City of Portland, Oregon
Bureau of Development Services
Land Use Services

**NOTICE OF A TYPE II DECISION ON A PROPOSAL IN
YOUR NEIGHBORHOOD – APPROVAL**

CASE FILE NUMBER: LU 16-247927 DZM
4018 N WILLIAMS APARTMENTS

SOUTH ELEVATION

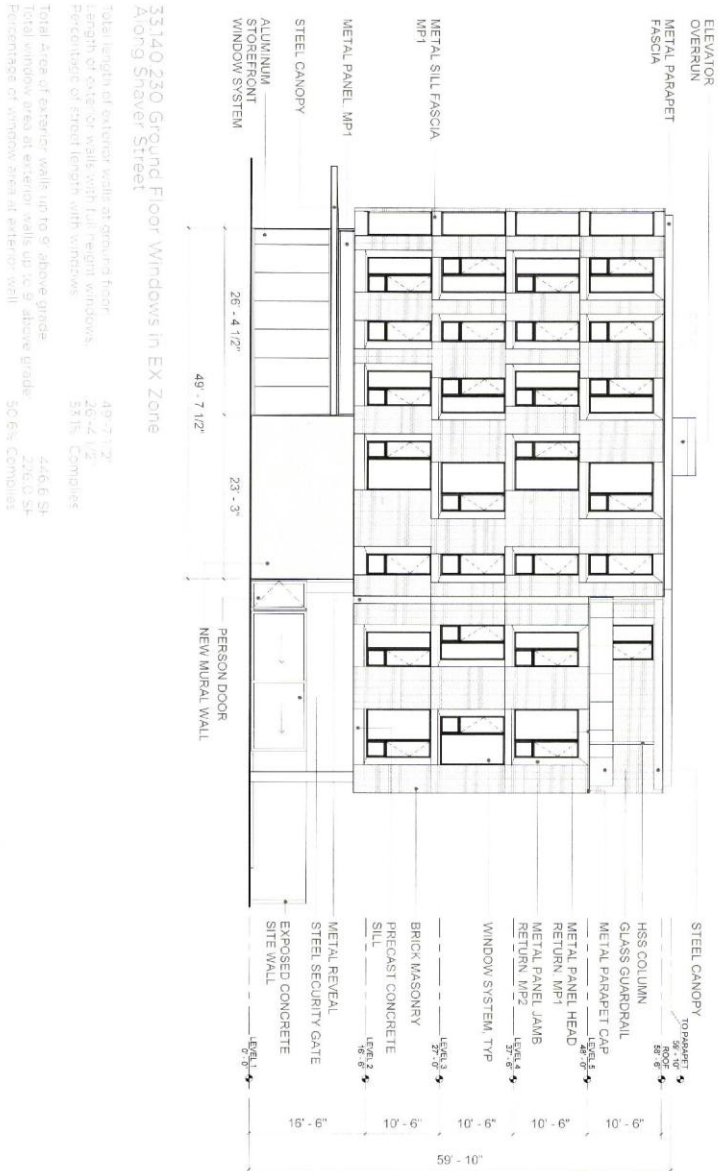
Due to inactive floor area on the building's skin at the southeast corner of the building (stair core, electrical and water riser room), blank concrete walls are oriented to the pedestrian realm abutting the NE Shaver St ROW. If left unmitigated, such a condition would not comply with approval criteria requiring visual interest along sidewalks. As mitigation to this blank wall condition, painted wall art is proposed at these locations (per Exhibits C-17 and C-18).

- Upper-level (floors 2-5) metal window jamb return panels expressed in a spectrum of 6 shades of blue.
- At all upper-level window jamb and head (top-floor only) returns and corner window spandrel, a 22-gauge metal is specified. The flat metal panel proposed in these applications, though, may be large and long enough to pillow or oil-can at 22-gauge thickness. An 18-gauge thickness or foam-backed 22-gauge metal would more suitably address these concerns and ensure quality in these important details.

With the condition of approval that the metal spandrel between the northwest and southwest corner windows shall be of 18-gauge thickness or 22-gauge backed with foam or like material, this guideline will be met.

- A. As part of the building permit application submittal, the following development-related conditions must be noted on each of the four required site plans or included as a sheet in the numbered set of plans. The sheet on which this information appears must be labeled "ZONING COMPLIANCE PAGE - Case File LU 16-247927 DZM." All requirements must be graphically represented on the site plan, landscape, or other required plan and must be labeled "REQUIRED."
- B. The metal spandrel between the northwest and southwest corner windows shall be of 18-gauge thickness or 22-gauge backed with foam or like material.
